Addendum No. 1

South Dry Sac Greenway Trail David C Murray Park to Fulbright Landfill Project # TAP 5901 (806)

Issued: March 9, 2017

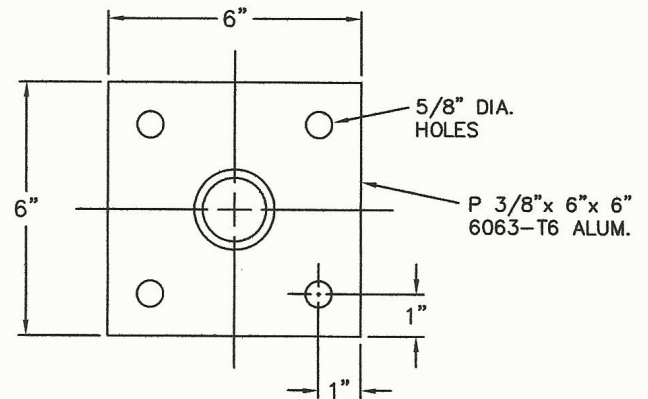
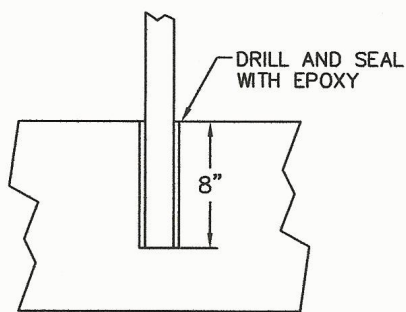
3. Refer to: **Division 2 Technical Specifications, Section 05100 – Prefabricated Steel Bridge, 1.02 Scope of Work, D.** The City of Springfield Standard ST-18 referenced in this section has been modified to delete the word “handrail” and replace it with the word “Guardrail”. Refer to the Revised Standard ST-18, dated March 8, 2017, attached to Addendum No. 1, and incorporated into the bid documents.
